NUREG-0712

Safety Evaluation Report

related to the operation of
San Onofre Nuclear Generating Station,
Units 2 and 3

Docket Nos. 50-361 and 50-362

Figure 17-1

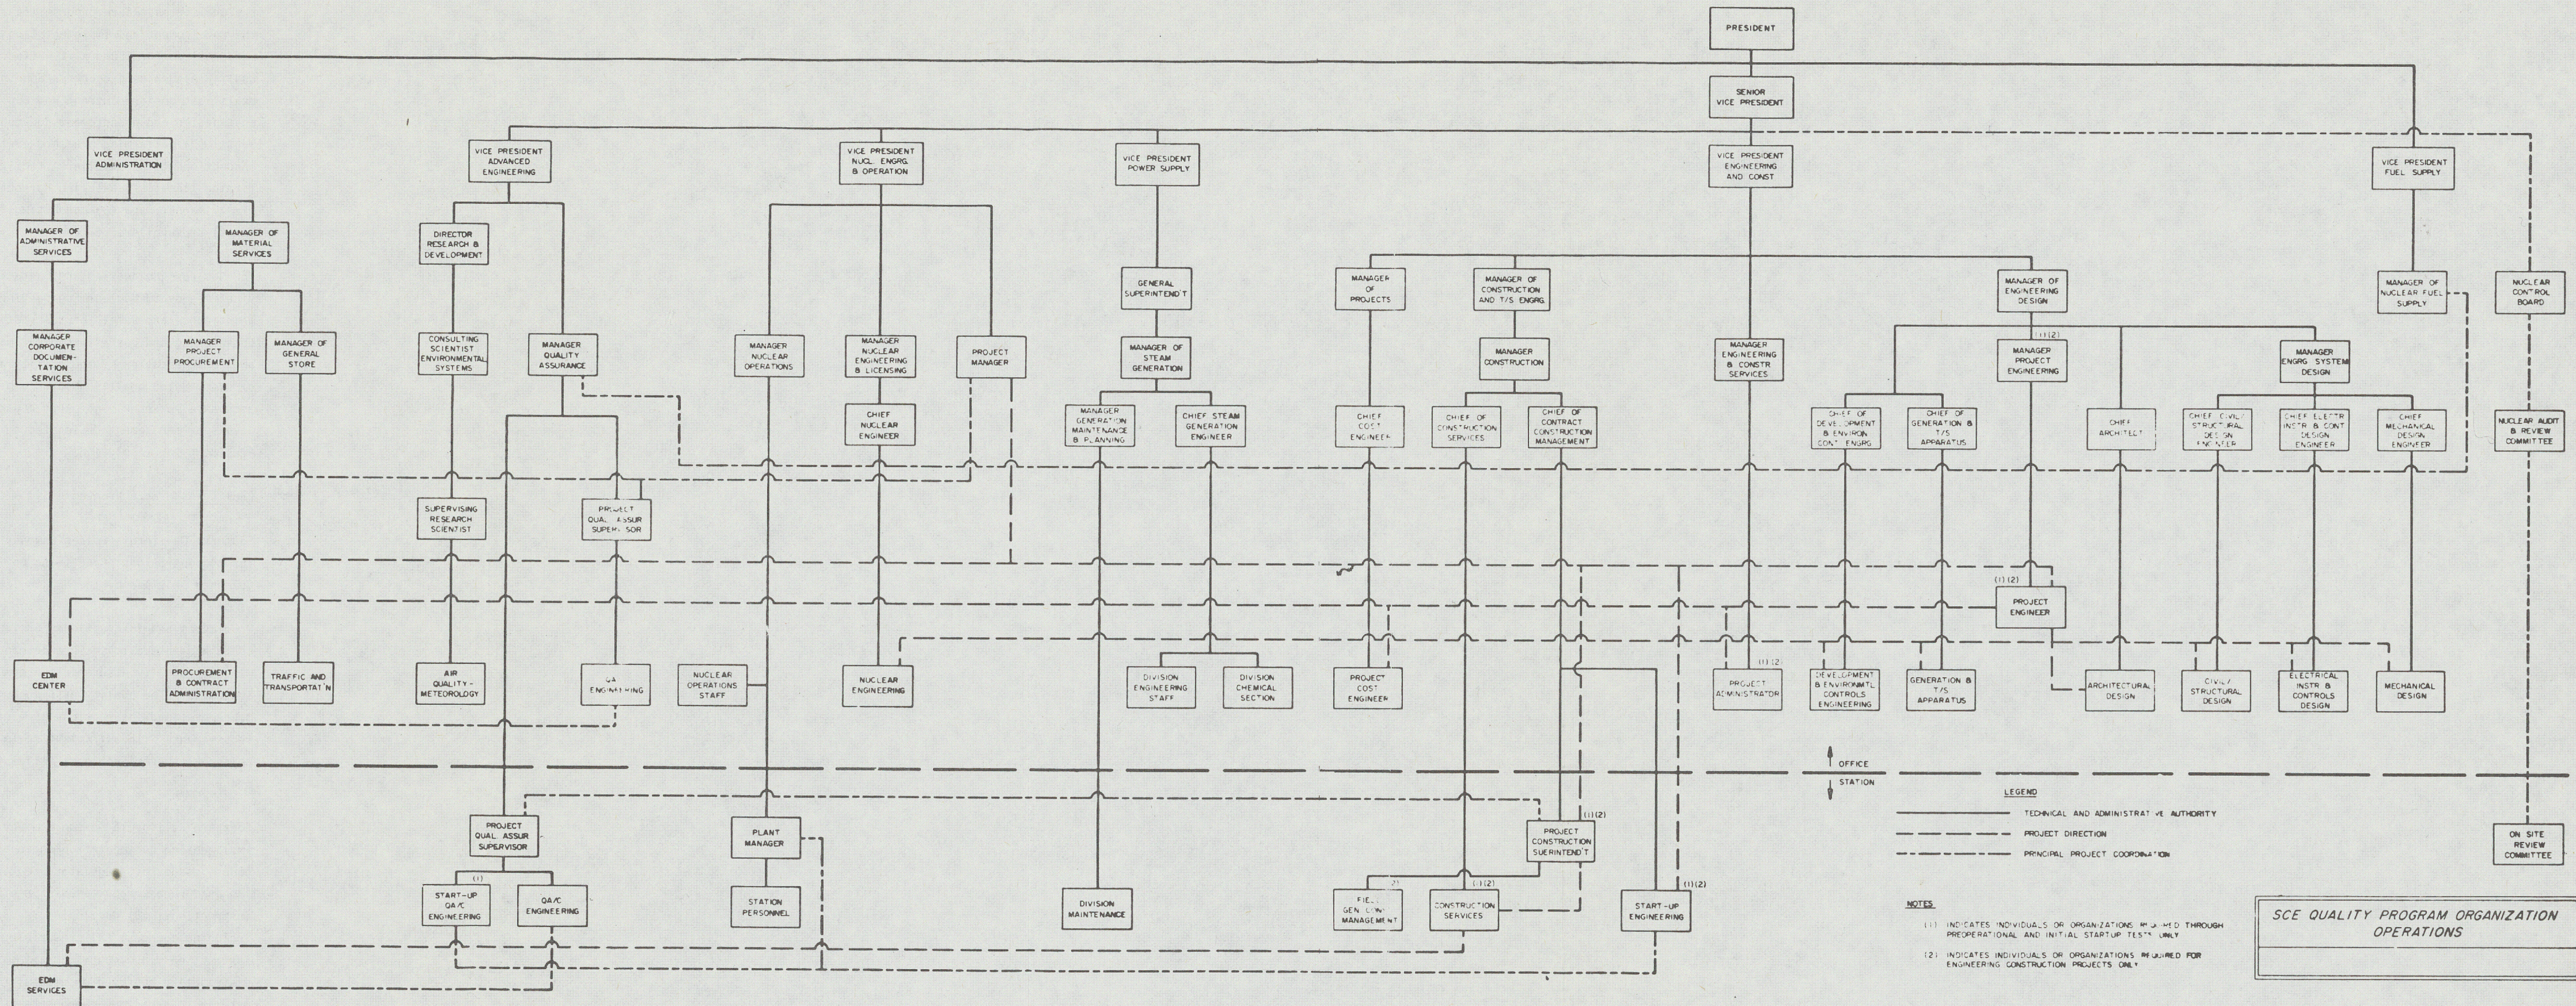
The structure of the organizational units responsible for the operation of San Onofre Units 2 and 3 and for the establishment and execution of the operations phase quality assurance program is shown in Figure 17-1. The Vice President, Advanced Engineering, who reports to the Senior Vice President, has the responsibility for establishing corporate quality assurance policies, goals and objectives and for executing the quality assurance program. The Manager, Quality Assurance, reports directly to the Vice President, Advanced Engineering, and has the responsibility for establishment, maintenance and surveillance of the quality assurance program.

Figure 361.45 - 1 Empirical Plot
Geologic Slip Rate VS Historical
Magnitude for Strike-Slip Faults

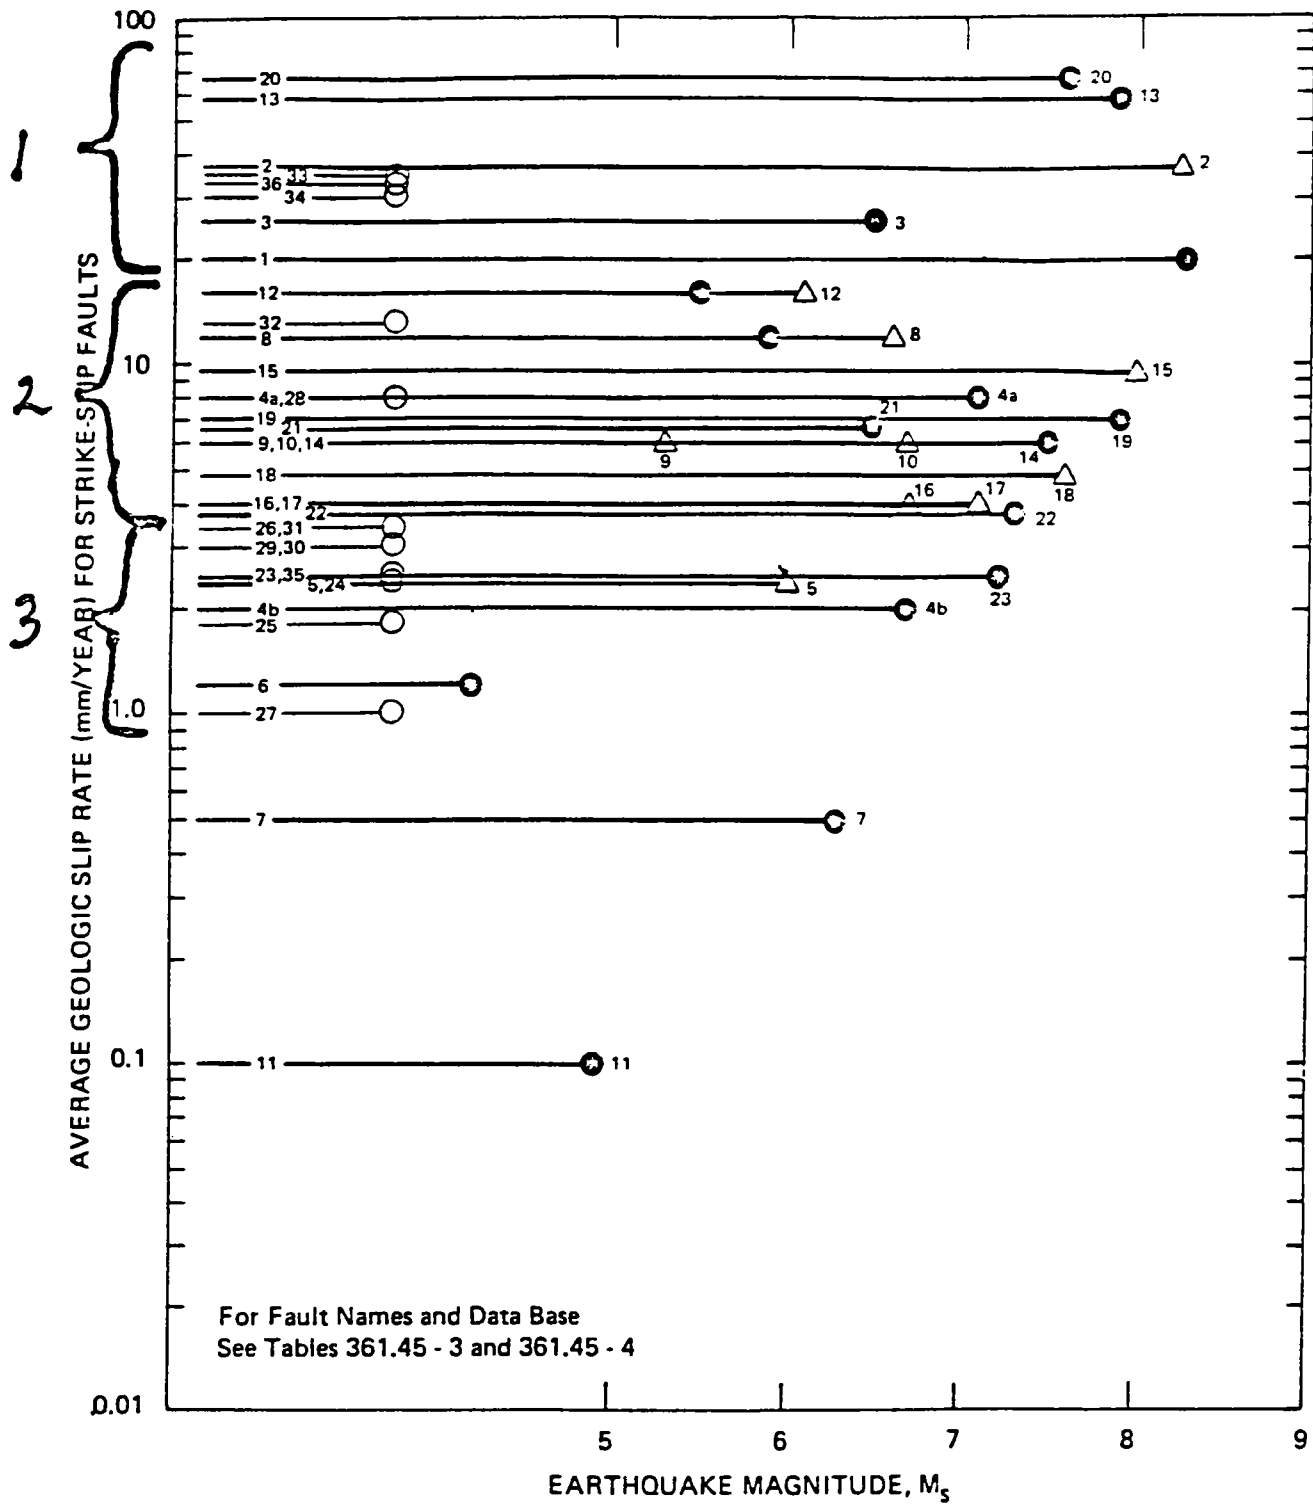
However, in an effort to be responsive to your requests to review the material submitted by the applicant, we offer the following comments concerning the primary technique discussed by the applicant, slip-rate versus magnitude study.

On the question of the statistical significance of the slope of a line bounding points on the log slip-rate versus magnitude plot, the applicant's consultants point out that while a single fault with low slip-rate is unlikely to have a "maximum" earthquake in historic time, a group of low-slip-rate faults has a significance proportional to their moment-rate sum. This same reasoning can be applied quantitatively.
